SUBJECT

Possible low power condition experienced with engine governing systems incorporating the AGB 250A3 integral actuator on 8 and 12 cylinder engines.

AGB 250A3

Figure 1

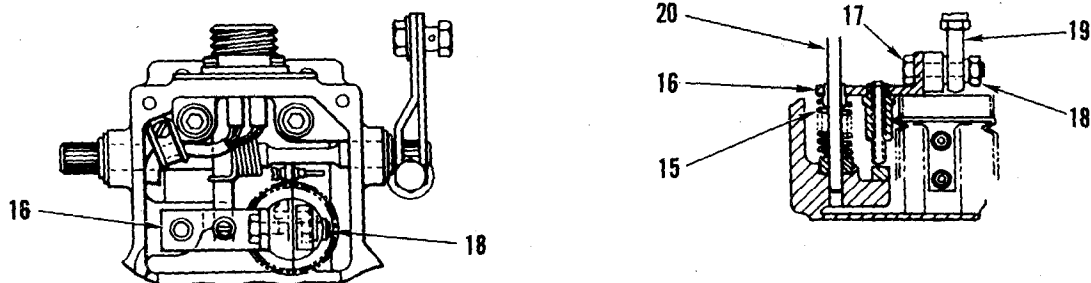
Recent product improvement was implemented partially by United Technologies Diesel Systems. The result may be that the fuel injection pump rack may only move part of its travel and may cause a low power condition at high actuator temperatures.

The present combination of the actuator's internal dust boot, spring and spring seat may cause a return force imbalance. The imbalance may prevent the fuel rack from moving completely to the full fuel position when the actuator is subjected to high temperatures. This condition is caused by the fact that a spring seat was prematurely installed. It should have been installed simultaneously with a new design dust boot.

This condition has only been experienced in a few applications and, if low engine power is prevalent, the following corrective action can be taken to remove the spring and spring seat.

- A. Remove rod end bearing (Pos. 19) by loosening its locknut (Pos. 18). Also remove shoulder screw (Pos. 17) and bracket (Pos. 16).
- B. Remove spring (Pos. 15) and its spring seat which rests against the actuator housing.

Replace spring (Pos. 15) with service part, SP 676. **DO NOT** re-install spring seat. Then re-install L bracket (Pos. 16), fasten rod end bearing (Pos. 19) with shoulder screw (Pos. 17) and locknut (Pos. 18). Torque to 4-5Nm (3-3.5 ft. lbs.).

NOTE: Check that L bracket (Pos. 16) is free to slide along spring retaining pin (Pos. 20) with no binding when rack is manually moved to maximum fuel position.

THIS IS AN IMPORTANT TEST - binding can cause loss of control resulting in engine damage.
